APPLICATION NUMBER: 25/0069

PROPOSAL: CONSTRUCTION AND OPERATION OF A MILL INCLUDING STORAGE OF RAW MATERIALS, TO PRODUCE 'GREEN' CEMENT FROM RECYCLED, NON-HAZARDOUS, WASTE MATERIALS, STORAGE OF THE PRODUCT AND ONWARD DISTRIBUTION

SITE: South Dock East Way Road Alexandra Docks, Newport

Site Plan rev F

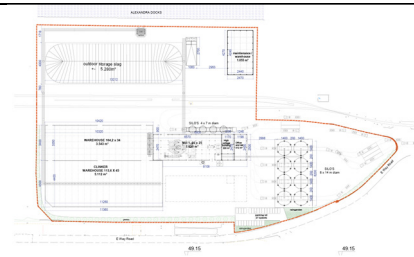
Indicative planting is shown on Site plan rev F but note this is not shown on rev H, and there is confusion over documents for example SAB Drainage Plan is the Sewerage Plan.

The indicative 2-3m wide strip to the south-east of the site is insufficient for meaningful GI with planting effectively occupying 'left over space' which is insufficient in scale relative to the development proposed.
